Bid Bulletin #02

PROJECT: Weeping Water Public Schools
Additions & Renovations
Weeping Water, NE

RE: Addendum No. 1 to the Bidding Documents for:
Weeping Water Public Schools
Additions & Renovation
204 West O Street
Weeping Water, Nebraska 68463
Schemmer Project No. 06368.001

This addendum consists of nine (9) pages of written addendum items and twenty-one (21) pages of supplemental drawings.

SHEET NO: SDA-6

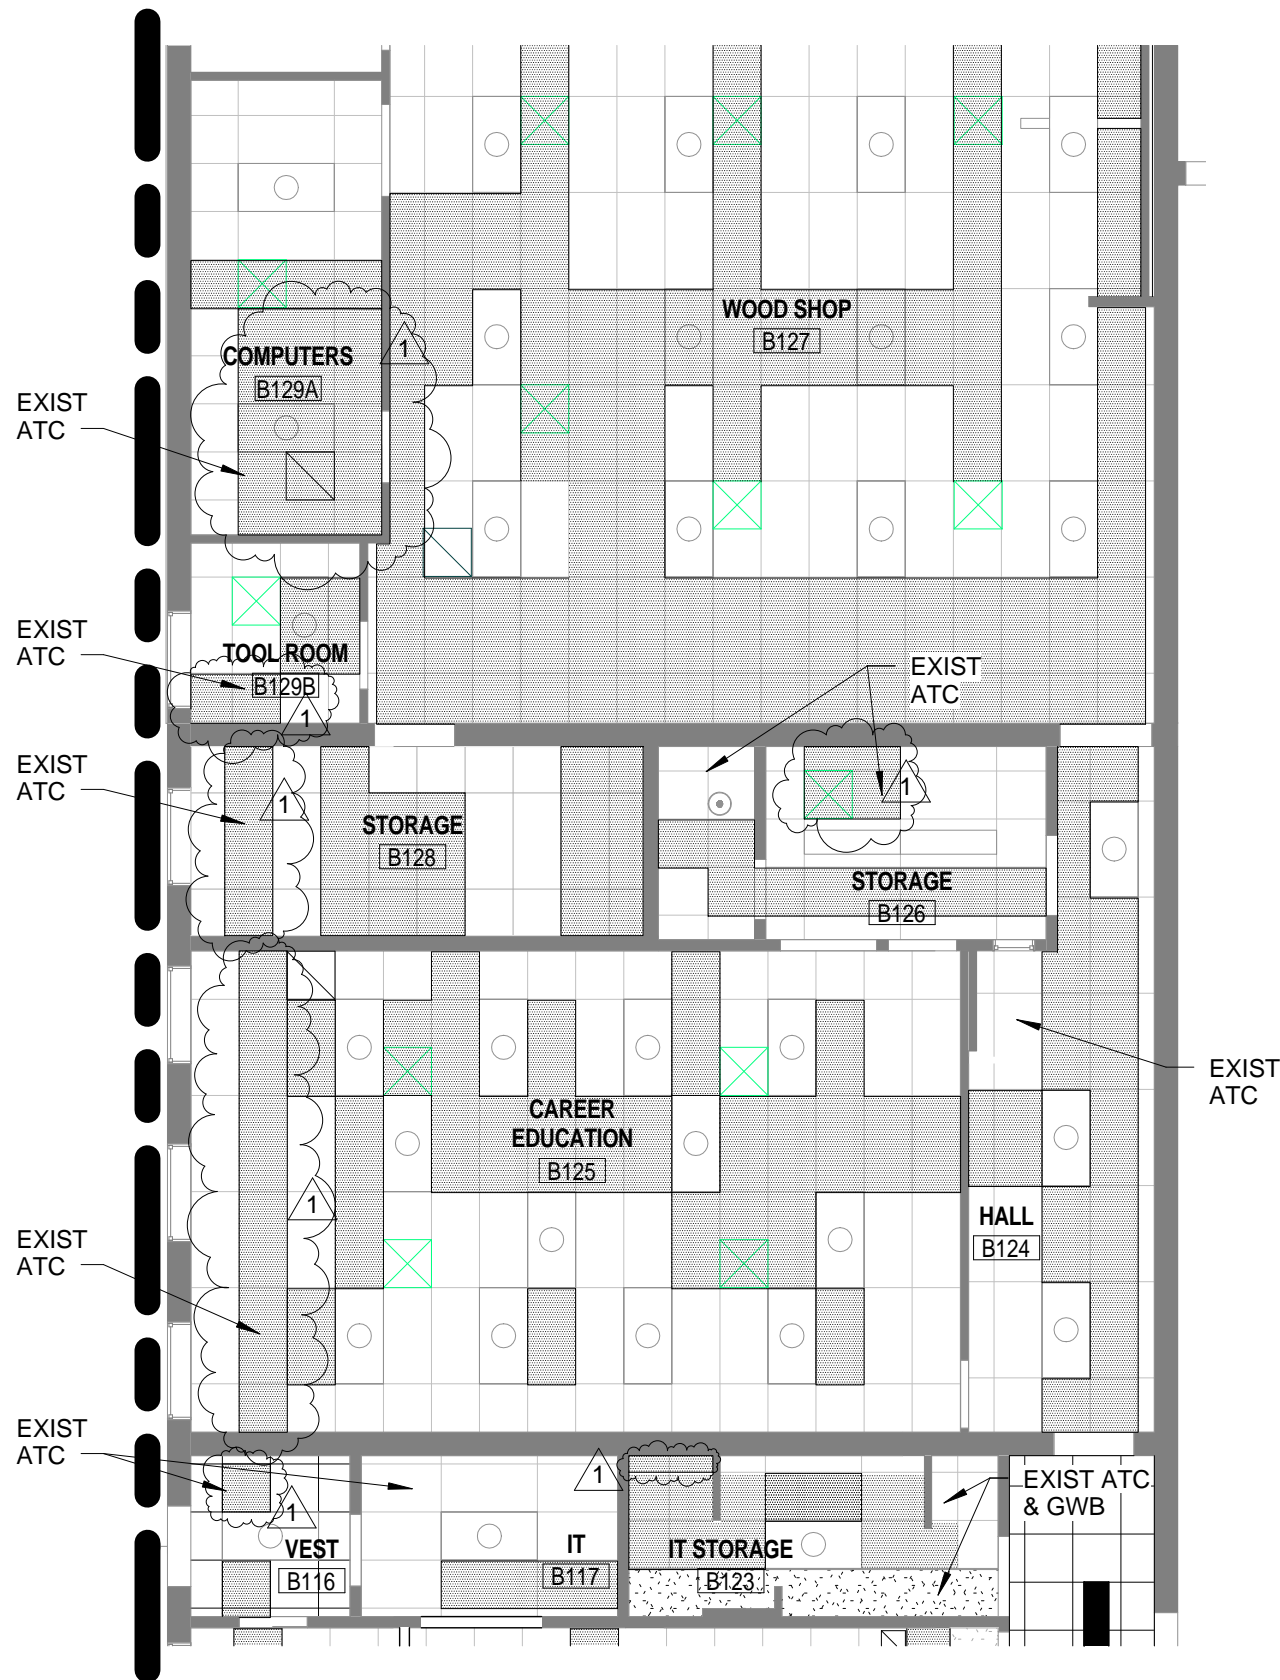
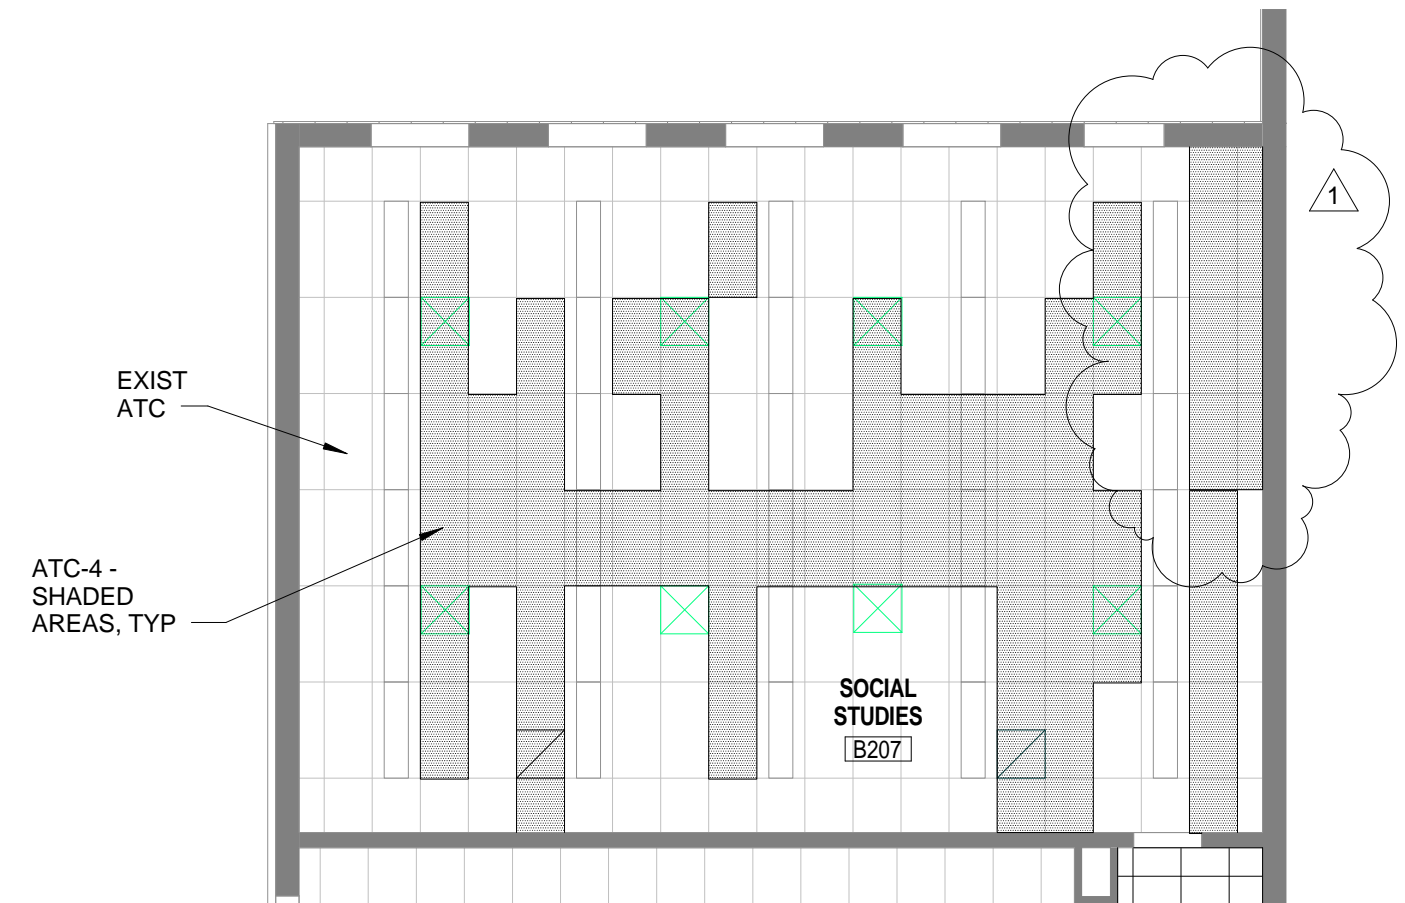
- 1) FIRST FLOOR PLAN – AREA B – REFLECTED CEILING
 - a. See 1/SDA-6 for revisions.

- 1) SECOND FLOOR PLAN – AREA B – REFLECTED CEILING
 - a. See 2/SDA-6 for revisions.

SHEET NO: SDA-7

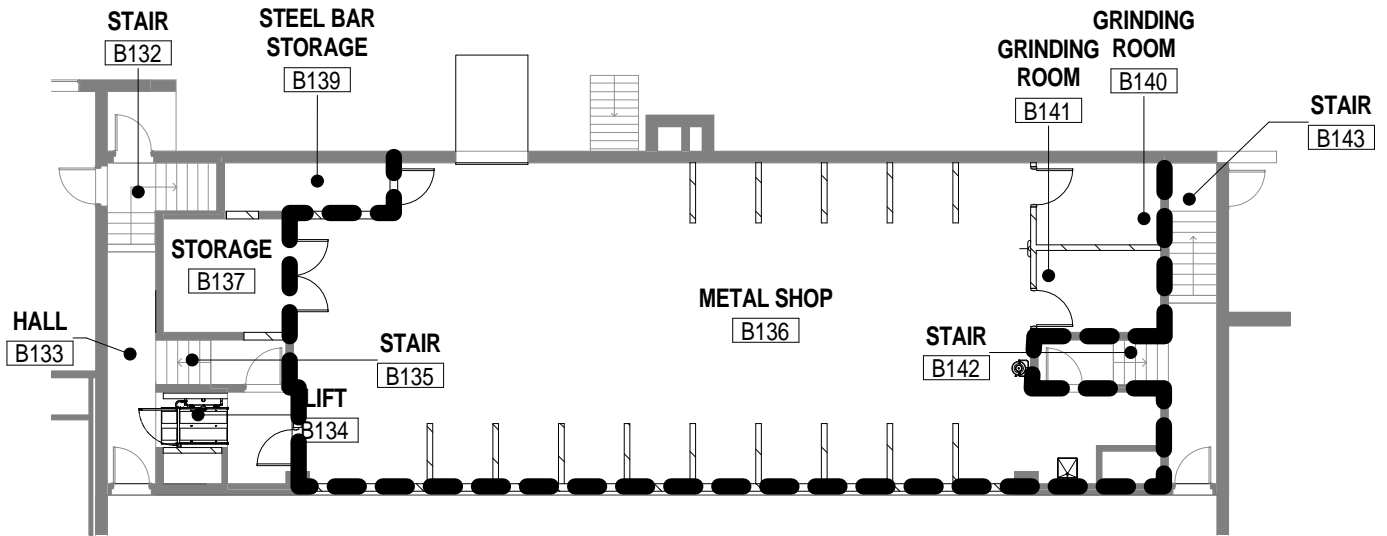
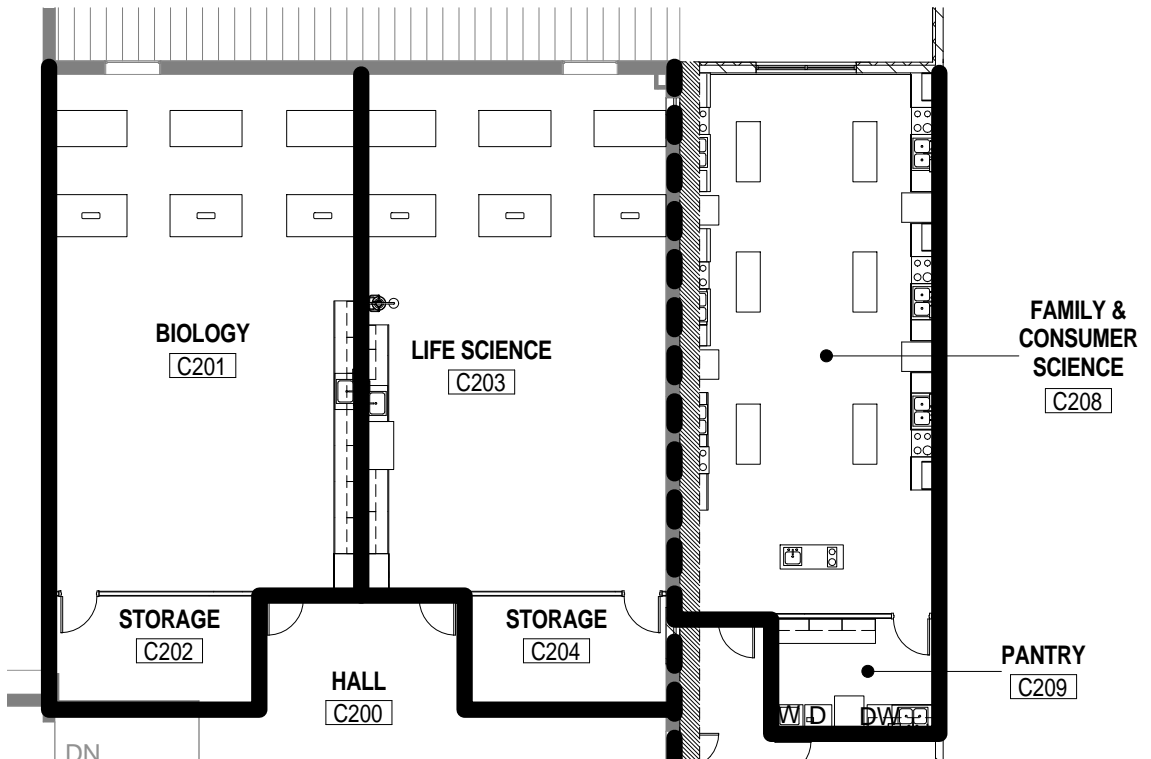
- 1) ADD Revisions on SDA-7, see attached.

- 1) ADD Revisions on SDA-7, see attached.

SHEET NO: SDS-1

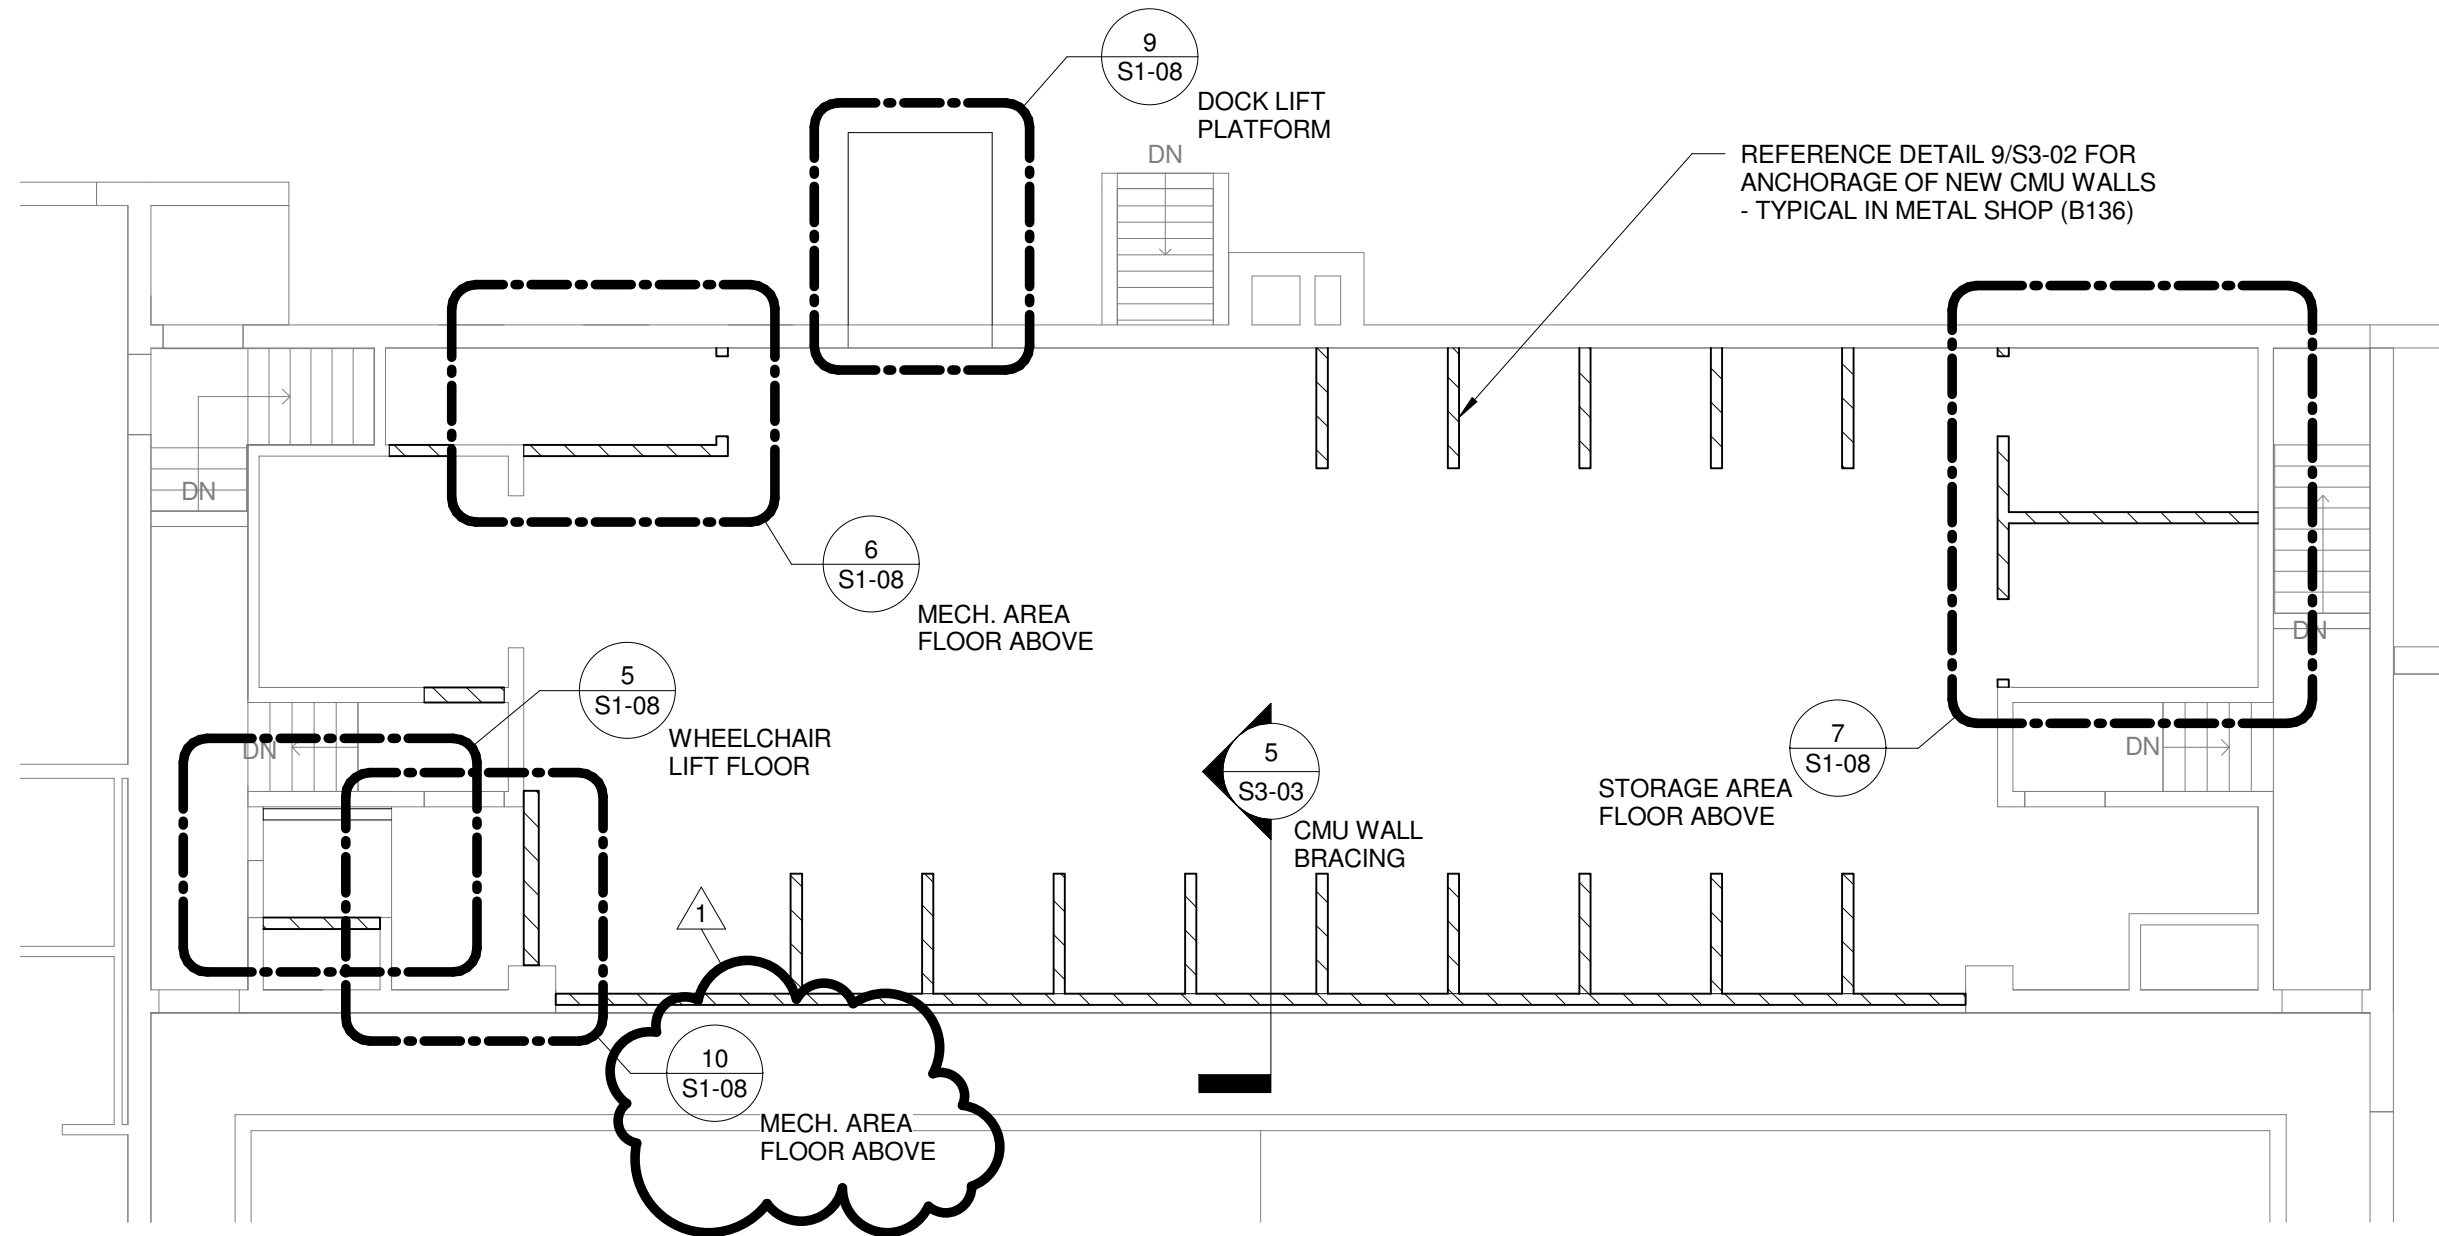
- 1) On plan 2/S1-08 (PARTIAL FIRST FLOOR PLAN – AREA B – METAL SHOP (B136)), ADD reference to plan 10/S1-08 (MECHANICAL AREA FLOOR (METAL SHOP B136)) as shown on attached supplemental drawing SDS-1.
- 2) ADD plan 10/S1-08 (MECHANICAL AREA FLOOR (METAL SHOP B136)) as shown on attached supplemental drawing SDS-2.

SHEET NO: SDS-3

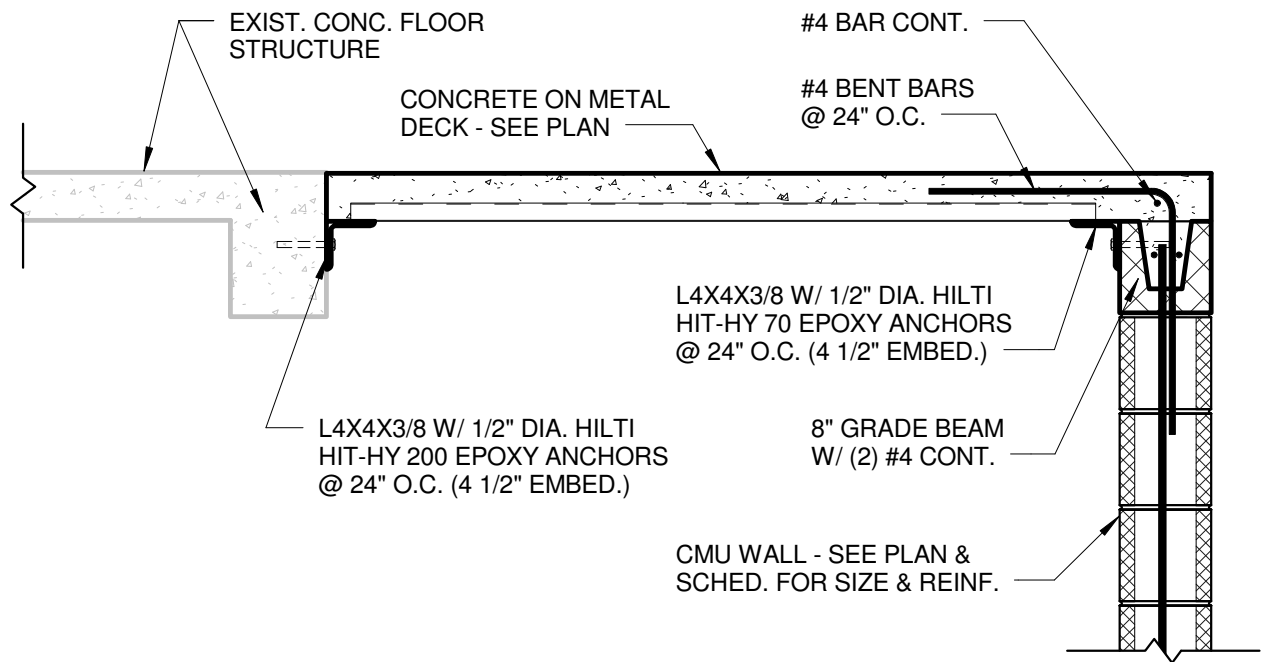
- 1) ADD detail 3/S3-08 as shown on attached supplemental drawing SDS-3.

SHEET NO: SDE-1

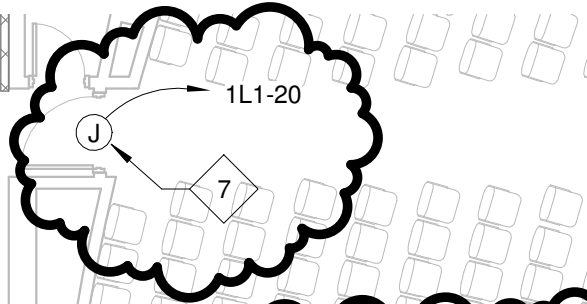
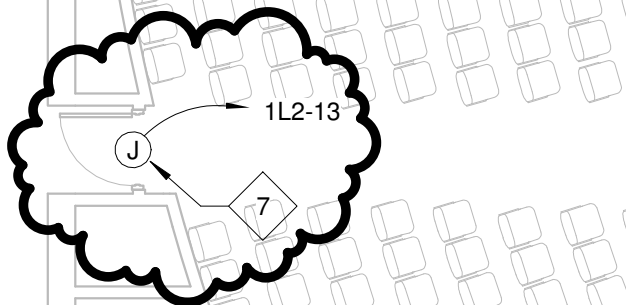
- 2) See attached SDE-1 for electrical revisions.

7. POWER FOR AUTOMATIC DOOR OPERATORS. PROVIDE RECEPTACLE AS REQUIRED BY MANUFACTURER. PROVIDE LOCAL DISCONNECT AND FUSE AS REQUIRED BY CODE AND AHJ.

SHEET NO: SDE-2

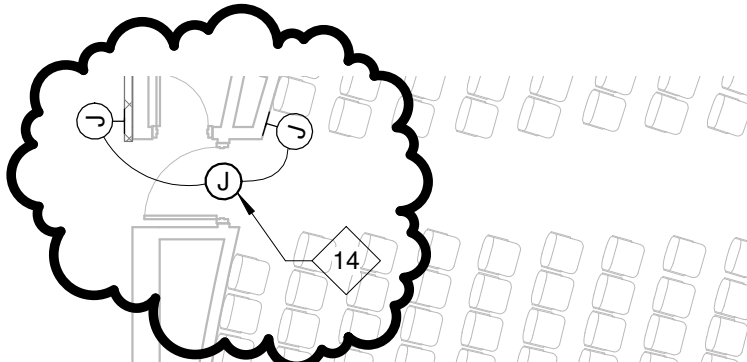
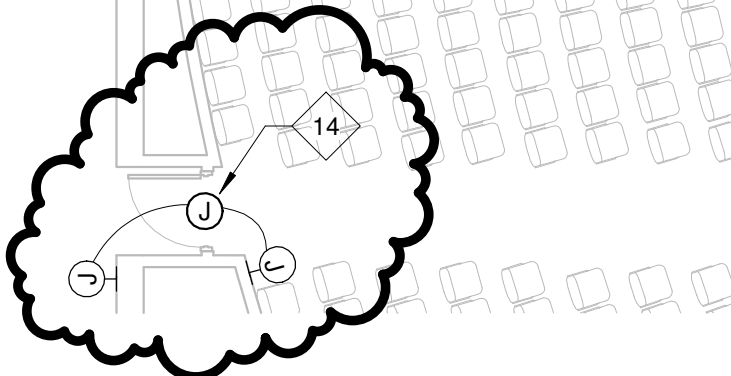
- 1) See attached SDE-2 for electrical revisions.

14. ROUGH-IN FOR DOOR AUTOMATIC OPERATOR. PROVIDE WIRING FROM CONTROLLER TO PADDLES. ELECTRICAL CONTRACTOR SHALL BE RESPONSIBLE FOR TROUBLESHOOTING AUTOMATIC OPERATOR WITH DOOR INSTALLER.

SHEET NO: SDE-3

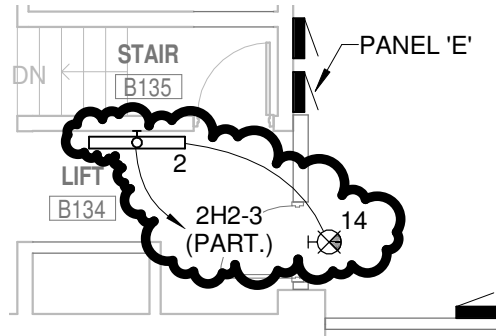
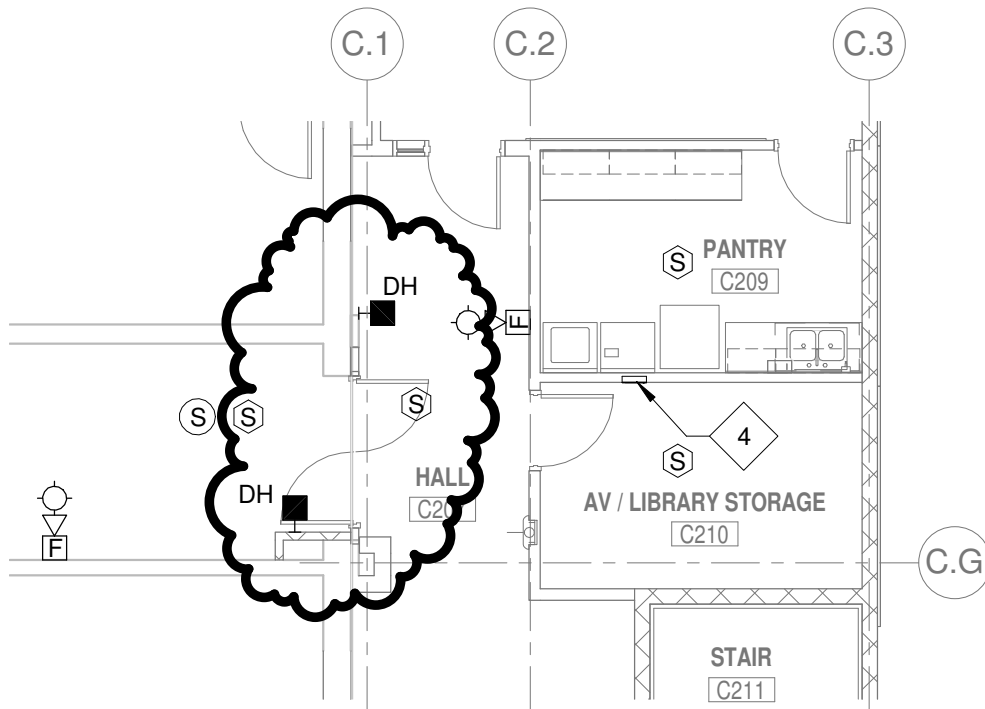
- 1) See attached SDE-3 for electrical revisions.

- 1) See attached SDE-3 for electrical revisions.
